### **REMARKS**

Reconsideration and removal of the grounds for rejection are respectfully requested. Claims 1-8 were in the application, claims 9-10 have been withdrawn, claims 1, 2, 3 and 5-8 have been amended, and claims 11 and 12 have been added.

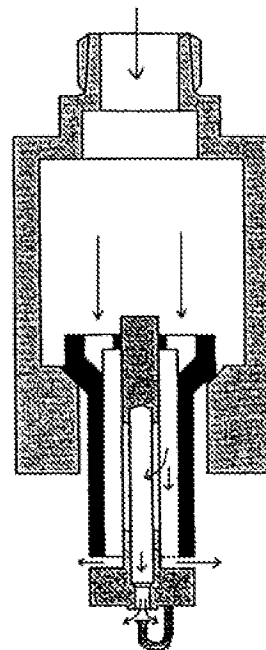
Claims 1 and 7 are not anticipated by Haisley. To begin, it is believed useful to review the operation of the applicants' invention. For reference, a version of Fig. 4, showing the liquid atomizer unit when in operation is depicted here.

In operation, the unit moves down into sealing engagement with the nozzle housing so that liquid entering the housing is directed through the holes or gaps located on the bottom 2 of the cup. All of the liquid then

distribution. The placement of a baffle face 18 in front of the hole 17 also provides more uniform distribution directly under the unit, as opposed to the Haisley unit where radial distribution is predominant.
